Briar Creek S/D road crossing NR2401.062

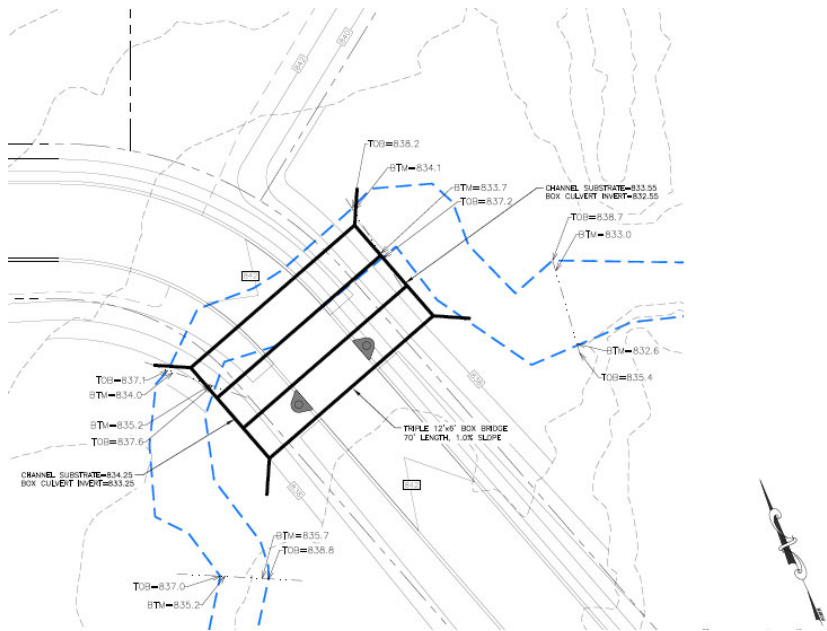
I just tried to give you a quick call, but didn't leave a voicemail. I'm looking over the application for the 3 ARAPs. With regard to the triple box road crossing, I'm a little confused on the detail. It looks like the flow (based on TOB) is only being directed through one of the boxes – is this one of the reaches where the width of the channel is only about 12'? Is there realignment proposed? I understand flow will be diverted while boxes are constructed, but the box/wing wall orientation doesn't appear to line up with natural stream flow. I may be misunderstanding. Thanks,
